FINAL
ENVIRONMENTAL IMPACT STATEMENT

SAN JUAN URBAN CORE TRANSIT SYSTEM

U.S. DEPARTMENT OF TRANSPORTATION
URBAN MASS TRANSPORTATION ADMINISTRATION

AUGUST 1983

FIGURE 12

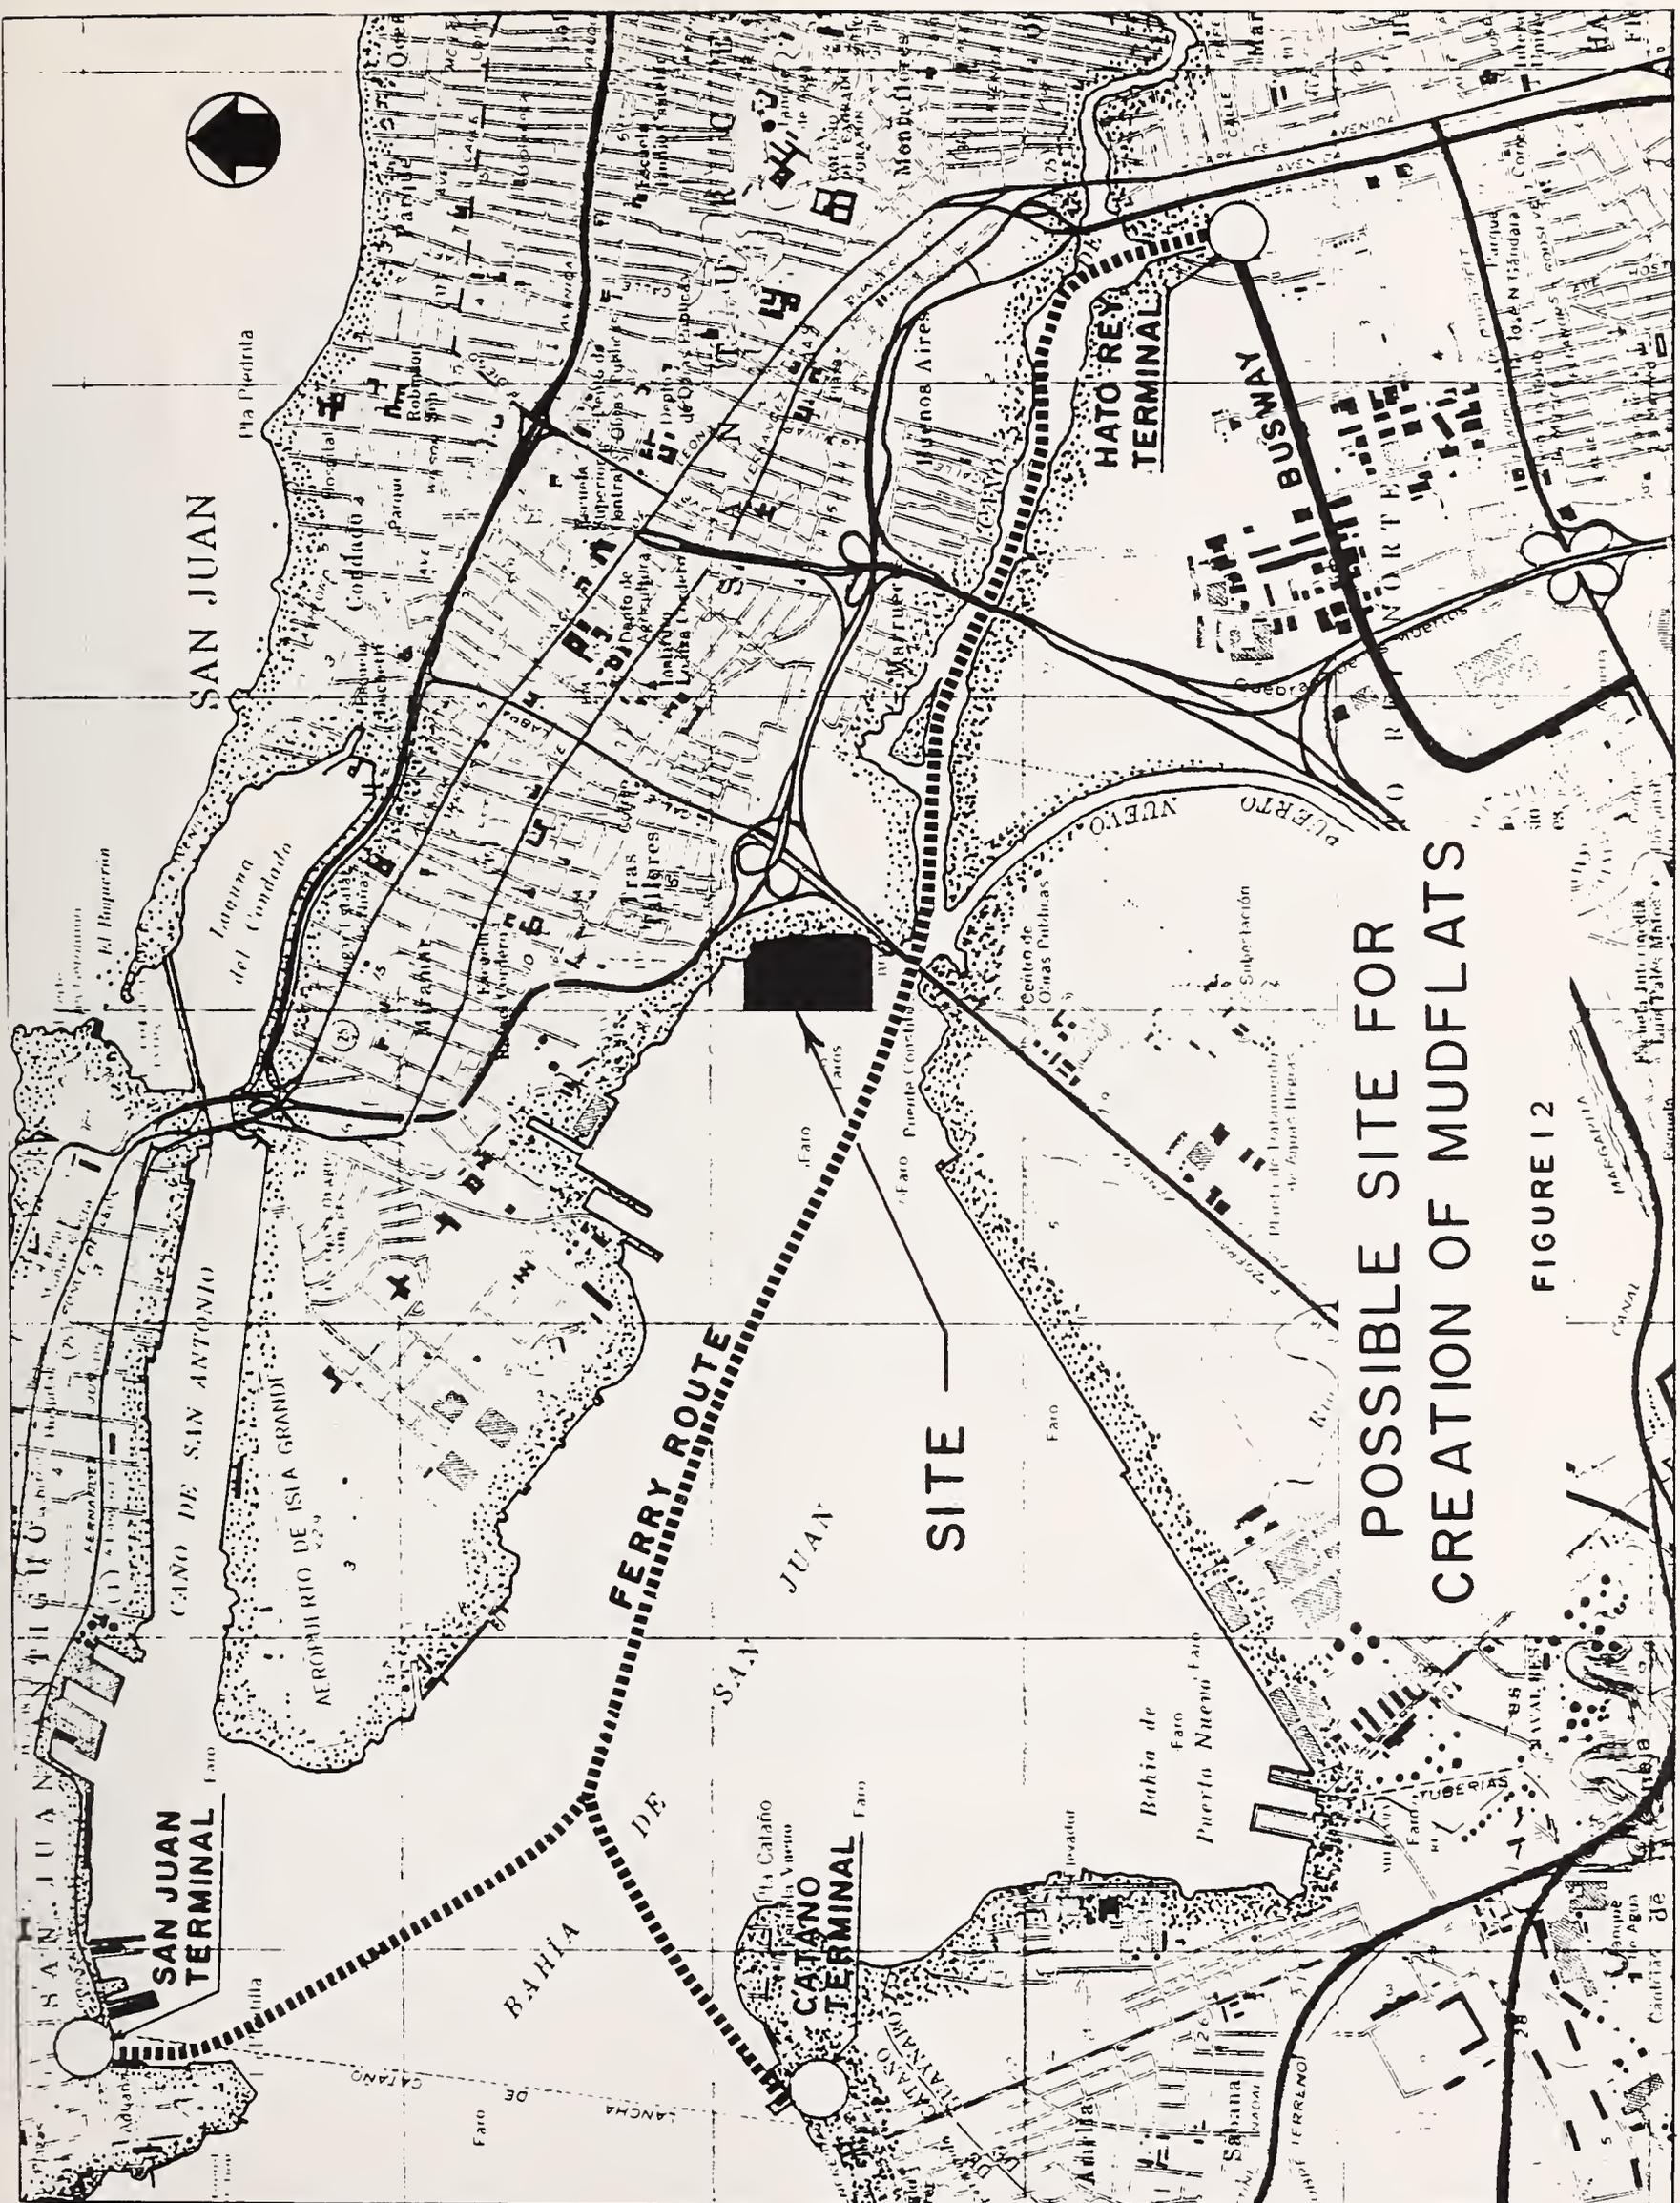
Page 76 - Mitigation Measures. We do not agree that Alternatives 2 and 5 would cause minimal mangrove losses. Sites for mangrove mitigation should be designated in the revised DEIS. Mudflat sites (Figure 12) need more study for suitability to accomplish mitigation.

Mangrove losses due to the preferred alternative will be compensated (See Section IV.G.3). The site shown in Figure 12 for mudflat creation is only a possibility as earlier discussed with officials of U.S. FWS and the Department of Natural Resources. Indeed, it requires further study.
